DEPARTMENTAL REFERENCE COMMUNICATION

- 0181 Frank, McCormick & Khalaf, LLC - Architects (Acadie Cajun and Creole Cuisine),
for installation of steel structure balcony, with possible encroachment onto City property,
at ~~424~~ E. Larned.
541

RE: Petition No. 181 – Frank, McCormick & Khalaf, LLC – Architects (Acadie Cajun and Creole Cuisine) for installation of a steel structure balcony, with an air right encroachment over City Property.

PETITION NO. 181
 FRANK, MCCORMICK & KHALAF, LLC ARCHITECTS
 28 W. ADAMS, SUITE 1400
 DETROIT, MI 48226
 c/o RICHARD C. FRANK
 PHONE NO. 313-234-8700

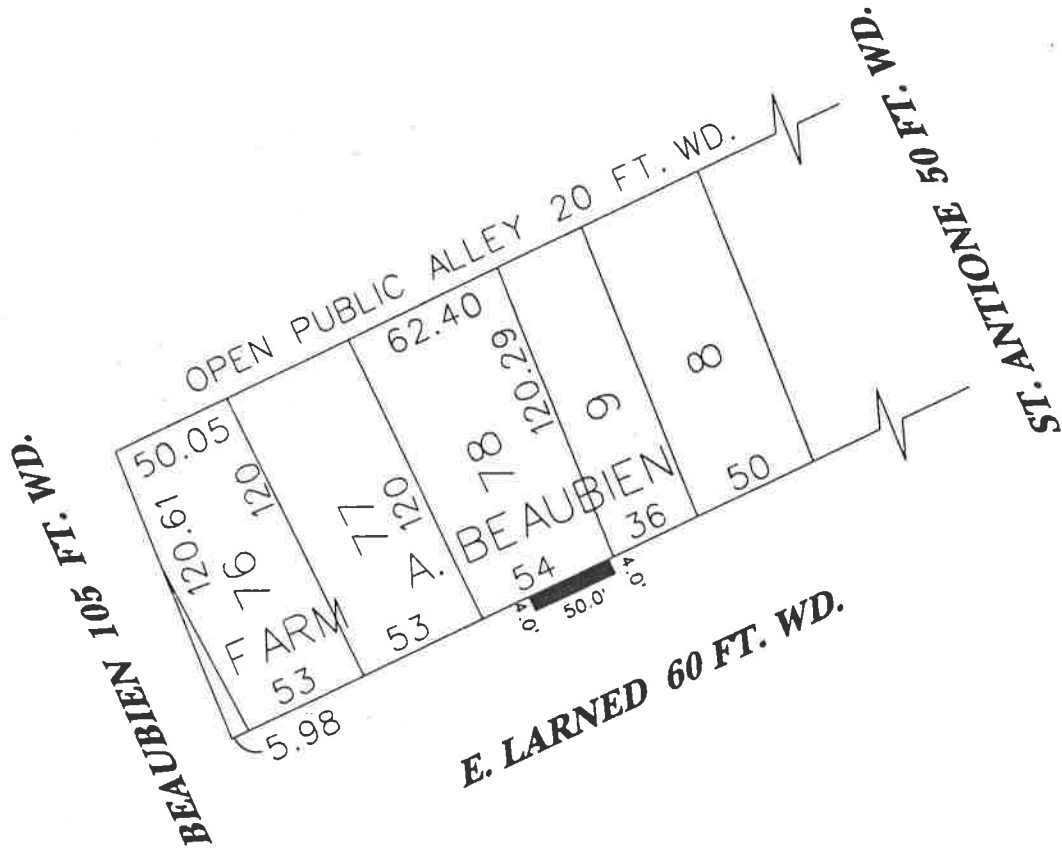
AREA OF ENCROACHMENT
 (HEIGHT FROM GRADE IS 17.00 FT.)
 (WIDTH IS 4.00 FT.)
 (LENGHT IS 50.00 FT.)

REQUESTED TO ENCROACH INTO THE AREA OF LARNED 60 FT. WD. WITH A BALCONY 4 FT. WD., 50 FT. LONG AND 17 FT. FROM GRADE.

PROVIDED, That No structure can be built over PLD installations, and any structure to be built shall maintain 4 feet and a half horizontal clearance from conduit banks and manholes; also a 10 feet horizontal clearance for the overhead PLD lines and installations; and be it further

PETITION NO. 181
FRANK, MCCORMICK & KHALAF, LLC ARCHITECTS
28 W. ADAMS, SUITE 1400
DETROIT, MI 48226
c/o RICHARD C. FRANK
PHONE NO. 313-234-8700

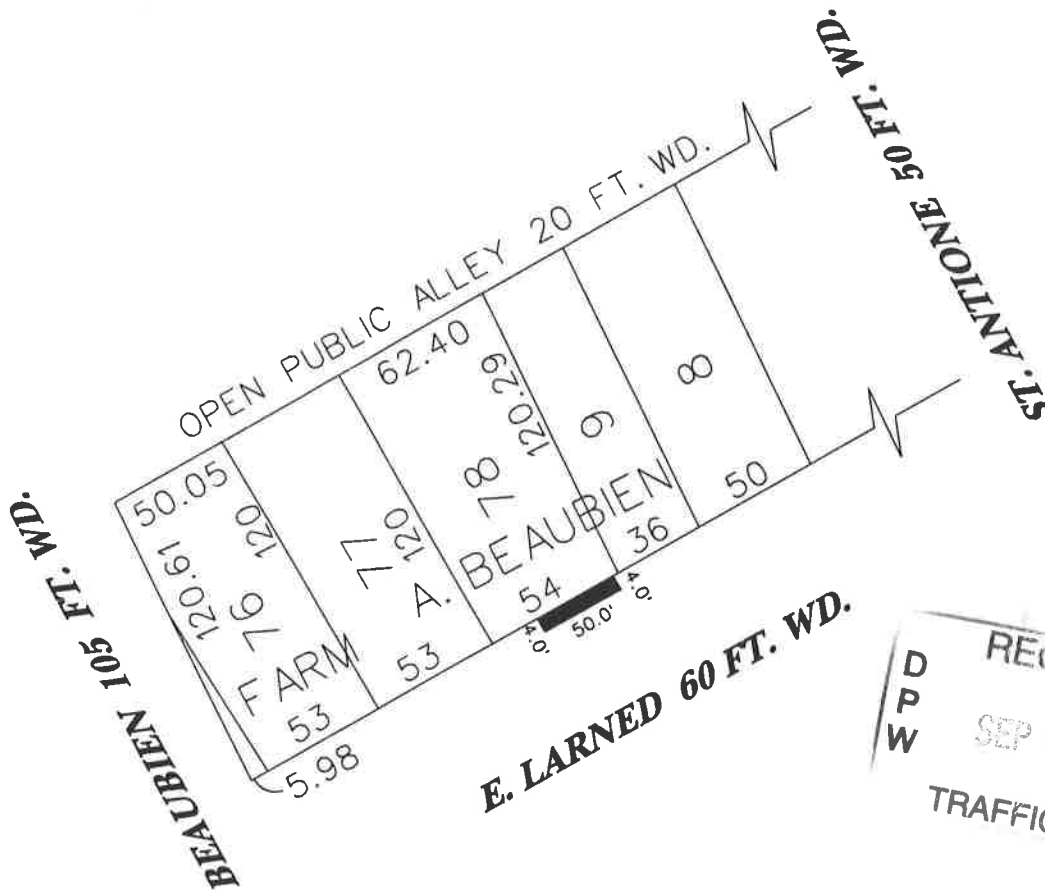
■ -AREA OF ENCROACHMENT
(HEIGHT FROM GRADE IS 17.00 FT.)
(WIDTH IS 4.00 FT.)
(LENGHT IS 50.00 FT.)

REQUESTED TO ENCROACH INTO THE AREA OF LARNED 60 FT. WD. WITH A BALCONY 4 FT. WD., 50 FT. LONG AND 17 FT. FROM GRADE.
